REVIEW OF IDWR'S MAY 31, 2012 STAFF REPORT

WATER SUPPLY EVALUATION FOR PROPOSED PROJECTS ALONG THE I-84 CORRIDOR¹

**Response to SPF's Memorandum
Entitled "Response to IDWR Staff
Memo Regarding the Sufficiency of Water
Supply For Water Right Applications and
Transfers Along the I-84 Corridor,"
November 15, 2012**

Figure 2

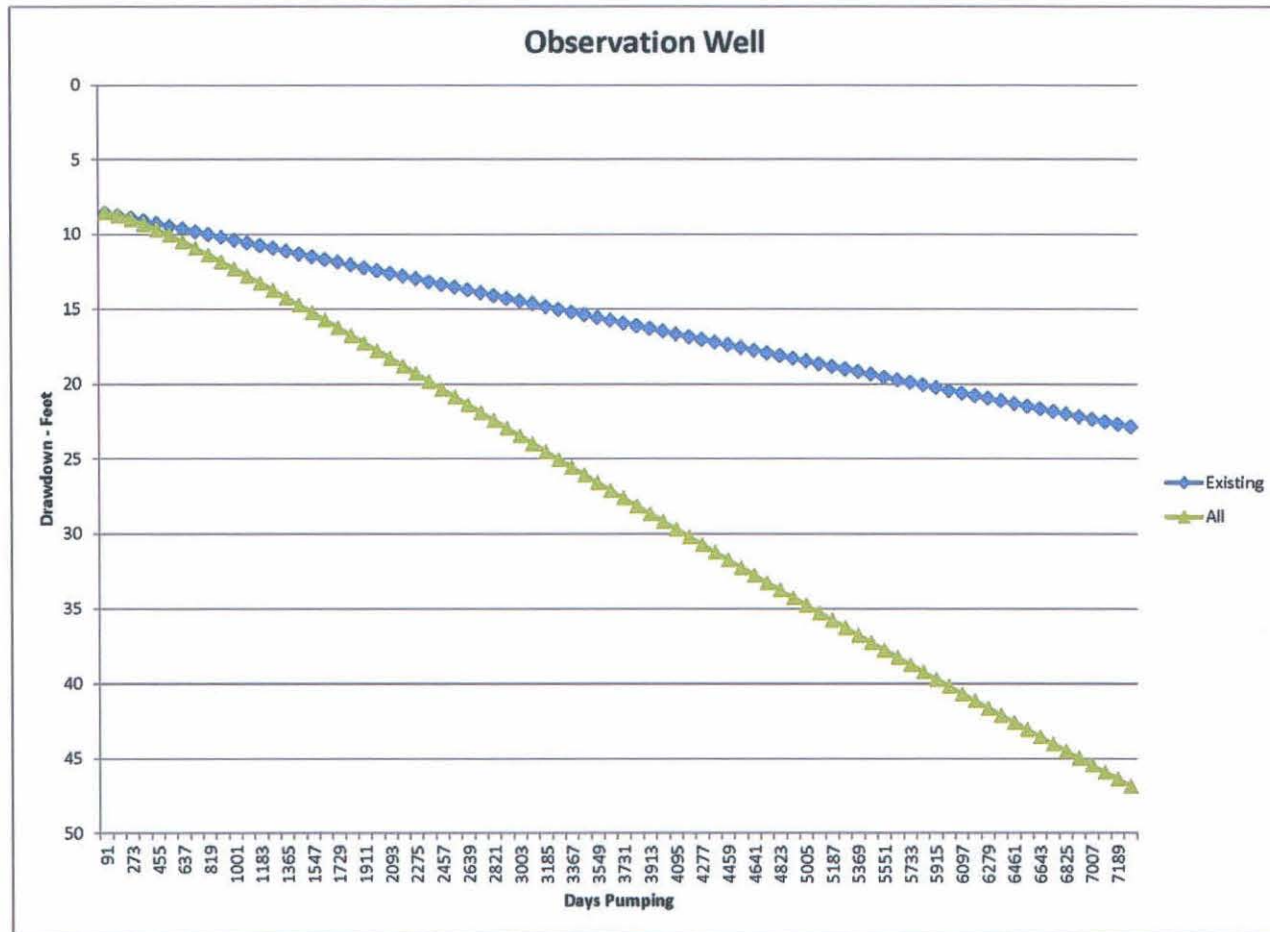
The existing permits, transfers and new water right applications were then added to the analysis and the second 20 year simulation was run a second time. The projected drawdown is shown on Figure 2 below as "All" and shows a drawdown of about 47 feet in the second 20 years, about double the drawdown that is forecast if existing conditions remain unchanged.

Figure 3

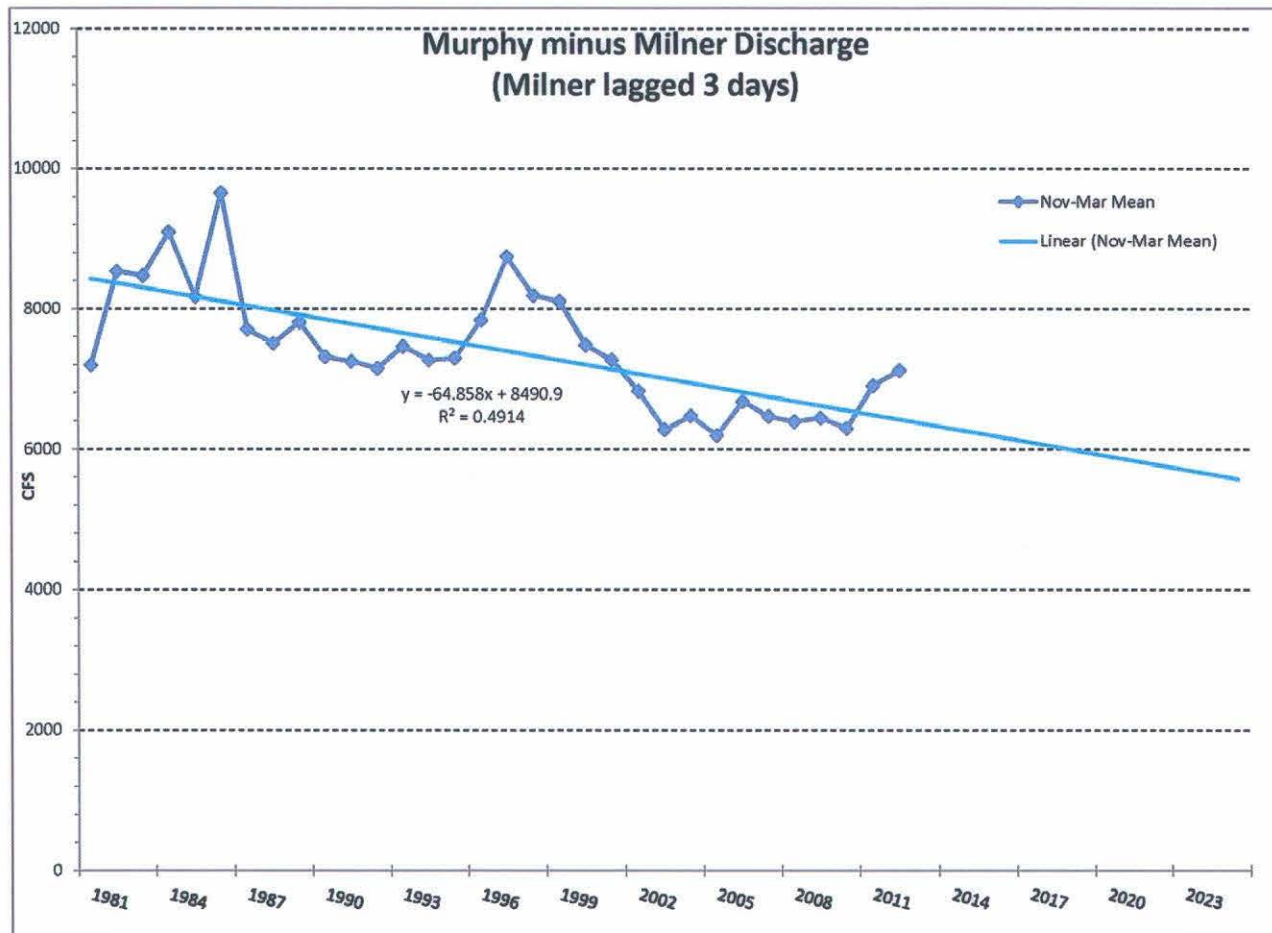
Figures 3 and 4 below were produced using mean daily flows for Murphy and Milner, modified as described above, and averaged for the winter and summer periods respectively. Figure 3 suggests the average mean daily winter discharge at Murphy, as modified above, has declined about 2,000 cfs since 1981 and is continuing to decline at about 65 cfs per year. Projecting this rate of decline forward from 2012 for 13 years suggests the average mean daily flow for the winter of 2025 will be 5,600 cfs, the winter minimum flow established by the Swan Falls Agreement and approved by the Idaho Legislature.

Figure 4

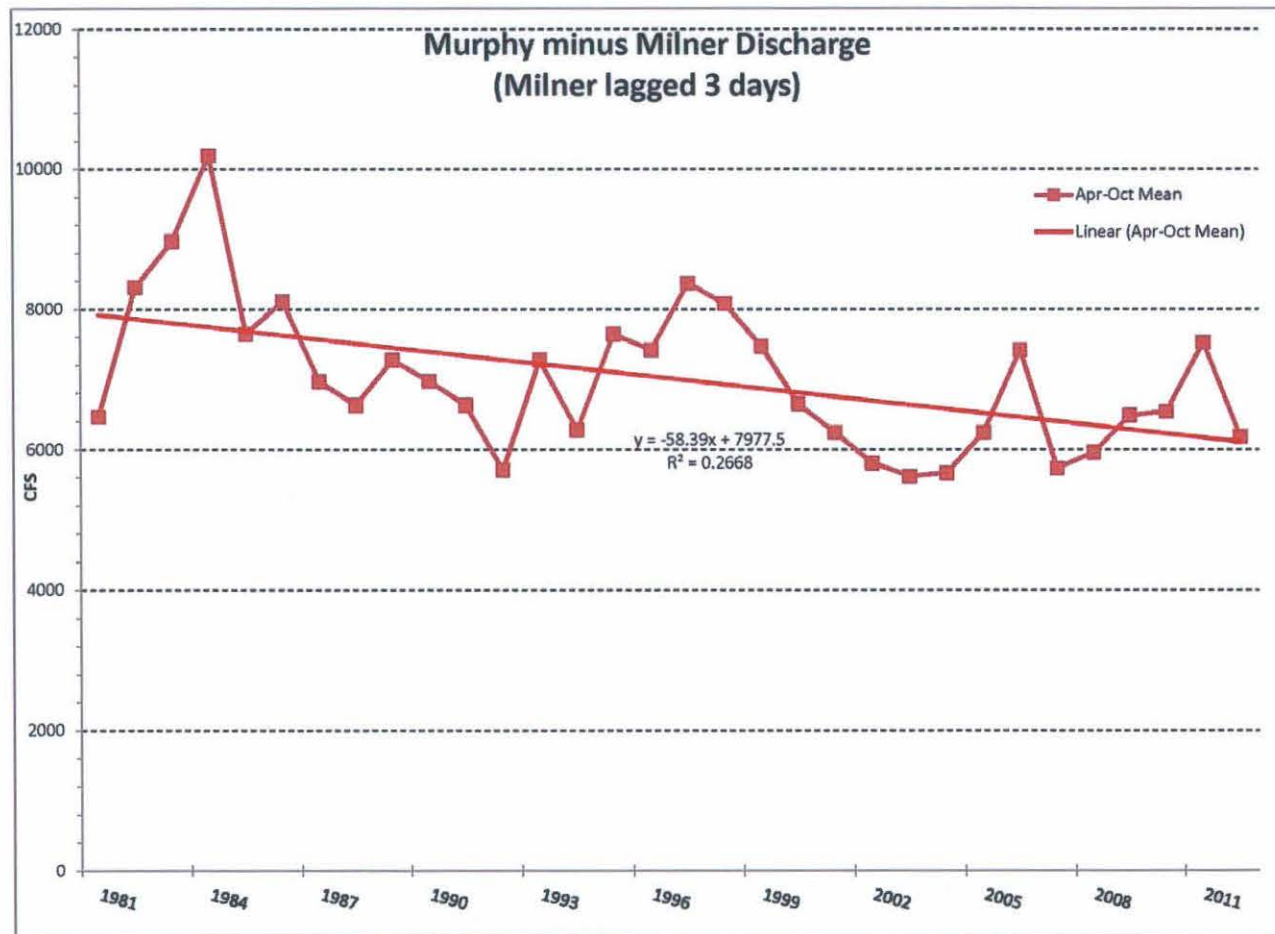
Figure 4 suggests the average mean daily summer discharge at Murphy, as modified above, has declined about 1,850 cfs since 1981 and is continuing to decline at about 58 cfs per year. The average summer flows are still high enough there is no immediate danger the entire average summer flow will decline to 3,900 cfs, the summer minimum flow established by the Swan Falls Agreement and approved by the legislature. Summer flows are, however, quite variable, and time periods shorter than the 7 months from April through October were examined to determine if one period was consistently lower than the entire summer period. To perform that analysis, monthly averages of mean daily summer flows at Murphy, as modified, were calculated for the months April through September with the lowest month being July.
